SERVICE BULLETIN

Bulletin Number: SB1407
Date: 8/15/14

Product Affected: WYK52FX730V5 & WYK60FX801V5 King Cobra mowers with serial numbers 201407U01147 and below

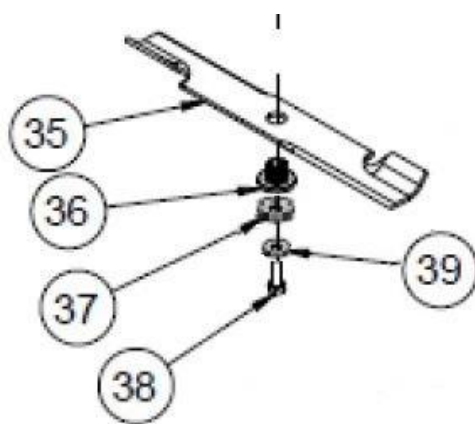
Situation: We had several customer requests to improve the durability of the spline driver 543085 used on the unit.

Solution: We worked with our supplier on the driver design and material composition. We also added a heavy flat washer as shown below.

Parts Required: In the future any orders for 543085 spline driver will be replaced with kit 542123 which contains the 543085 spline driver 103038 flat washer. The parts manuals will be updated as well.
